## Give Me Some Flow

### The Glitch

## The Fix

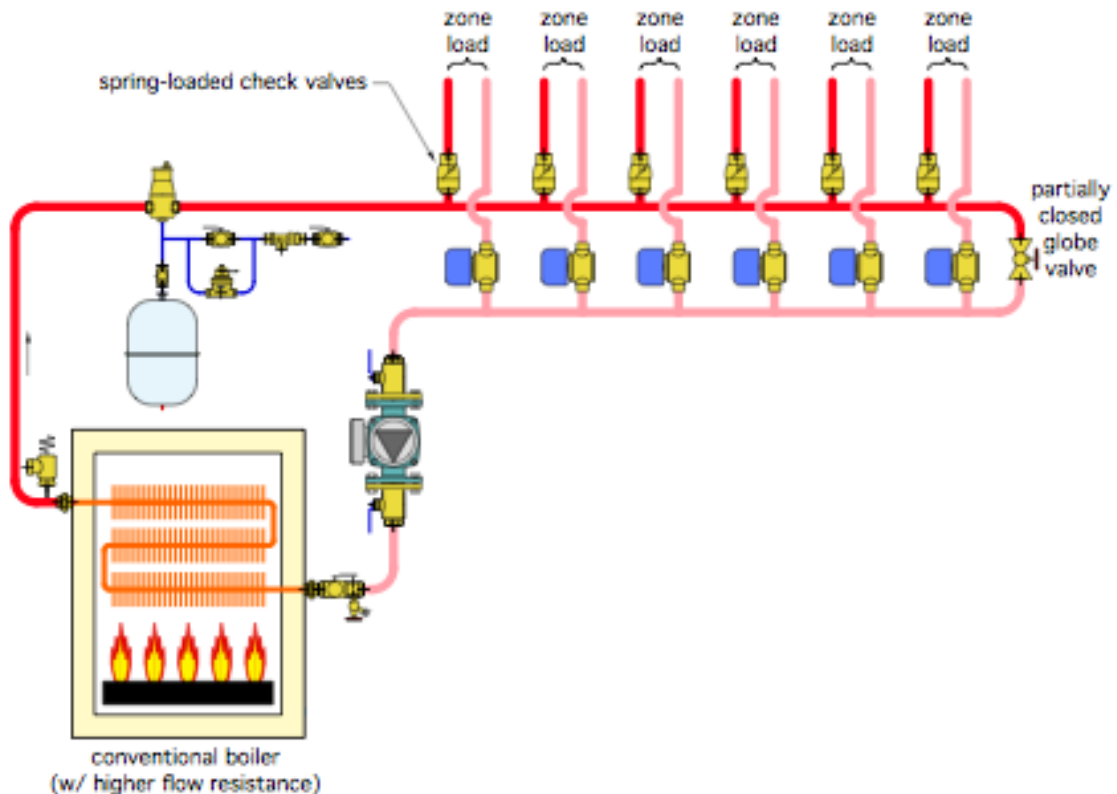
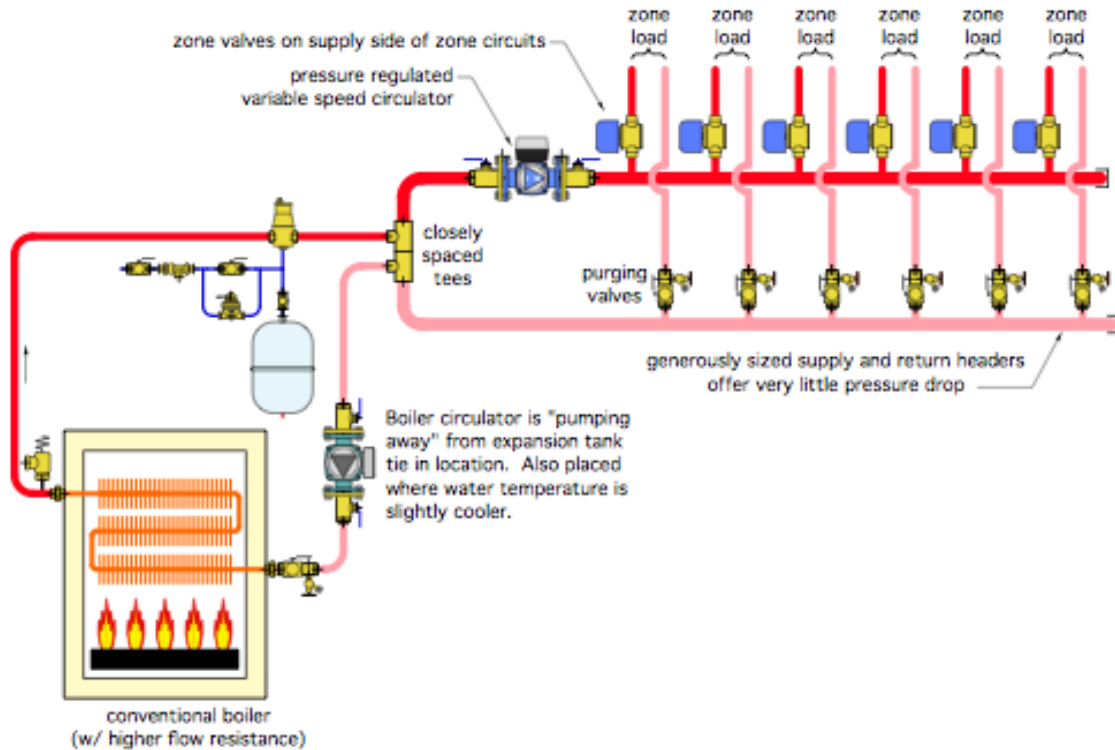
1. The high-flow resistance boiler will create significant variation in zone flow rates depending on which zones are open. If the boiler has low thermal mass, there could be an additional problem with flow starvation under low-load conditions.

2. The partially closed ball valve is a very poor excuse for proper control of differential pressure across the headers. The variable-speed, pressure-regulated circulator is now the state-of-the-art method for providing such control in systems using valve-based zoning.

3. Headers should always be generously sized to minimize pressure drop along the length of the header. This plays a big part in providing hydraulic separation between the load circuits.

5. It's never a good idea to install check valves near fittings that creates high turbulence. This is the case with the check valves shown in the glitch drawing. There should always be at least 12 diameters of straight piping upstream of any check valve to calm turbulence that otherwise will cause the check valve to rattle.

6. Purging valves on each zone circuit are missing in the glitch drawing. They are shown in the fix.

7. The circulator location in the glitch drawing, in combination with the likely pressure losses of the piping system, puts the circulator in a "pumping toward" rather than "pumping away from" situation with respect to the expansion tank.

4. Any "flow-sensitive" boiler supplying a system using zone valves should be decoupled from the distribution system through some means of hydraulic separation. In the fix drawing, this is accomplished with a pair of closely spaced tees. It could also be accomplished using a hydraulic separator or a buffer tank between the boiler and the distribution system.

However, heat migration in this system is eliminated by simply installing the zone valves on the supply side of the zone circuits. Do this and there is no need of installing the check valves.
